Work Order ID 99870

Item Name: Crosstube Aft

DART AEROSPACE LTD	Work Order:	99870
Description: Crosstube High Aft (205/212)	Part Number:	D212-664-201
Inspection Dwg: D212-664-241 Rev: D		Page 1 of 1

DRAWING NO. D212-664-241	TITLE CROSSTUBE ASSY (205/212 HI AFT)	REV. D	DART AEROSPACE LTD ENGINEERING ORDER		D.E.O. NO. D212-664-241-D-1	SHEET NO. SHEET 1 OF 2	SCALE NTS
DRAWN	CHECKED	MFG. APPR.	APPROVED	DE APPR.			
DATE 11.04.07	DATE 11.04.11	DATE 11.04.12	DATE 11/04/12	DATE 11.04.12

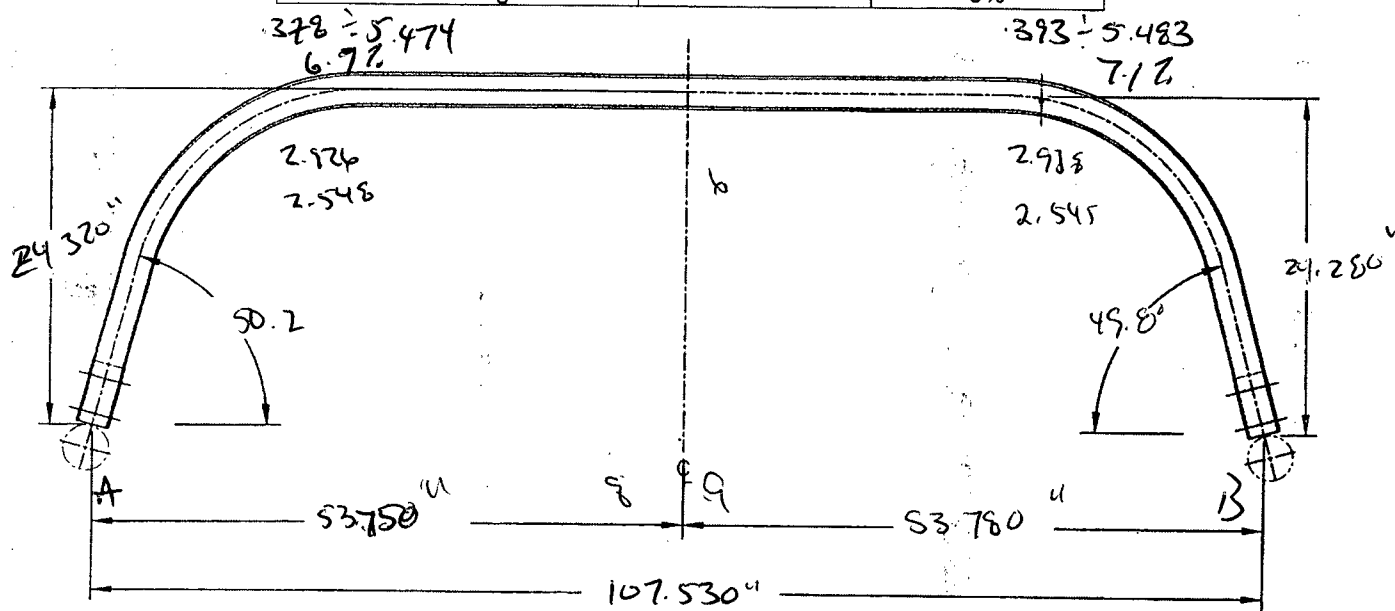
Side A	MIDDLE	Side B
Bending Passes	8	6	9
Crushing	6.97		7.17
Comments			
Side A = 6.97% crush @ 8 passes			
MIDDLE = 6 passes			
Side B = 7.17% crush @ 9 passes

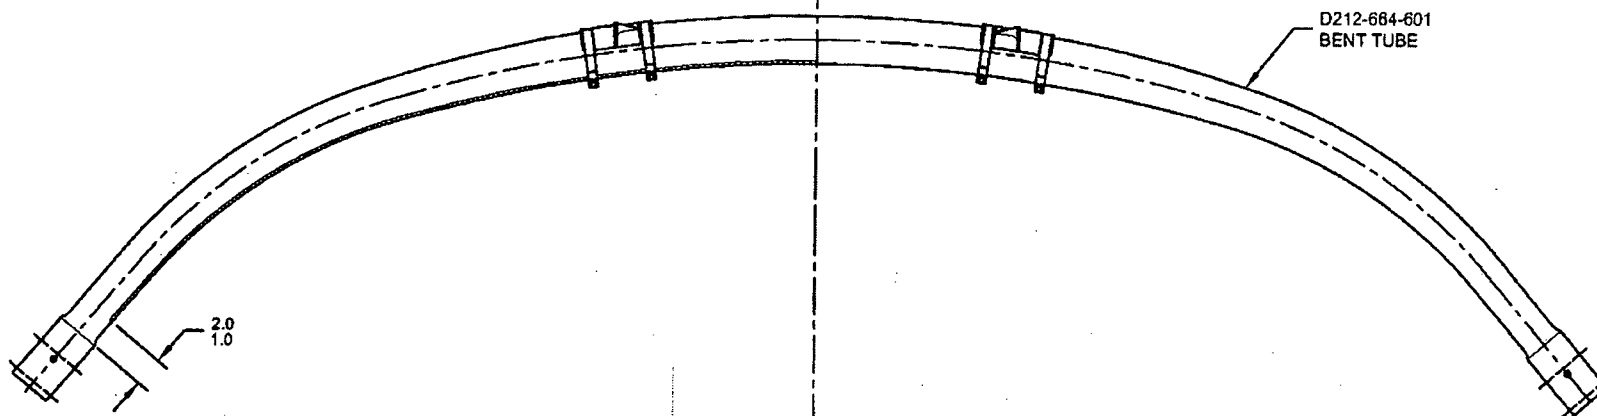
PURPOSE:

ADD AN INSPECTION WINDOW TO UNDERSIDE OF CROSSTUBE.

NOTES 2 OF SHEET 1 IS AMENDED AS FOLLOWS:

- 2) FINISH: CHEMICAL CONVERSION COAT PER DART QSI 005 4.1
PRIME INSIDE AND OUTSIDE PER DART QSI 005 4.2
MASK UNDERSIDE OF CROSSTUBE AS SHOWN (HATCHED AREA) AND
PAINT OUTSIDE PER DART QSI 005 4.2
REMOVE MASKING AND APPLY CLEAR COAT

MASK AREA PRIOR TO PAINTING,
REMOVE MASKING AFTER PAINT
AND APPLY CLEAR COAT

FIGURE 1: SUPPORT INSTALLATION

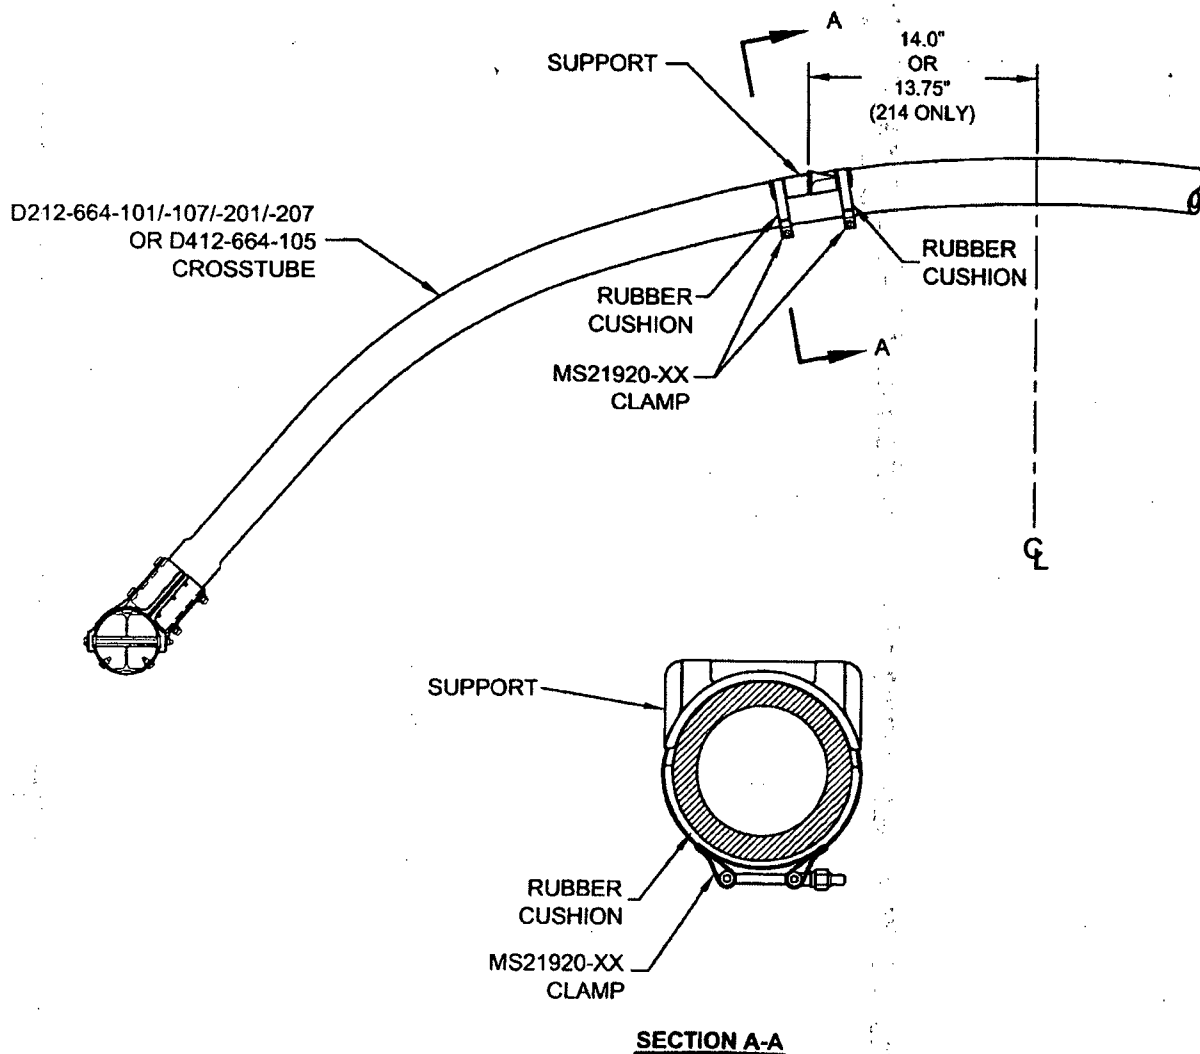
For the crosstubes listed above, section 32.4 of ICA-D212-664 is amended as follows. Use Figure 1 of this service instruction and Figures 32-2 to 32-9 of ICA-D212-664 for further reference. For crosstubes of an earlier change number, it is recommended that if the supports are removed, the supports should be reinstalled using the procedure listed below.

- 32.4.1 Locate the area on the crosstube for installation of support (see Figure 1 of this service instruction). For D212-664-101/-107/-201/-207 and D412-664-105 crosstubes, the outward face of the support tabs should be 14.0" (355mm) from the crosstube center for 204/205/210/412/UH-1 aircraft. For installation on 214B/B-1 aircraft, the outward face of the support tabs should be 13.75" (349mm). Ensure paint finish of crosstube is intact; touch up as required per Chapter 5 (5.3.9) of ICA-D212-664.

- 32.4.2 If present, remove any paint/primer on bottom of supports. Abrade mating surfaces of support and crosstube with 400-grit sandpaper. Saturate a clean cloth with MEK or 4105S Wash'n'Wipe Degreaser or equivalent and wipe until there is no residue.

- 32.4.5 Apply a 0.04" to 0.07" thick layer of Proseal 890 Class B or AMS-S-8802 Class B sealant underneath applicable support and install support as shown in Figure 1 of this service instruction.

- 32.4.6 Install the clamps opposite to crosstube support as shown in section A-A of Figure 1. Install rubber cushions underneath each clamp around the bottom circumference of the crosstube up to the crosstube centerline. Torque clamps 80-100 in·lb (9.0-11.3 Nm). It is acceptable to use smaller or larger sized MS21920-XX clamps than those listed in ICA-D212-664, ensure that after torquing the clamps per this instruction, the nuts are in safety but not bottomed out

(CRUSHING OF D212-664-201

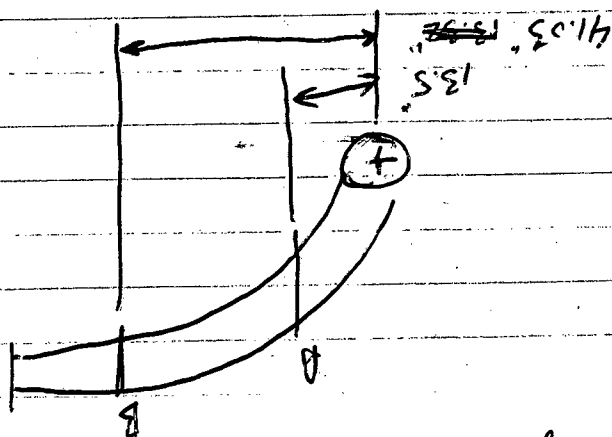
Acceptability of 8% CRUSHING

Point A: $OD = 2.548$ in $OD = 2.492$ in
 Crushing $(2.992 - 2.548) / (2.992 + 2.548) = 8\%$
 $I = 1.476$ in⁴
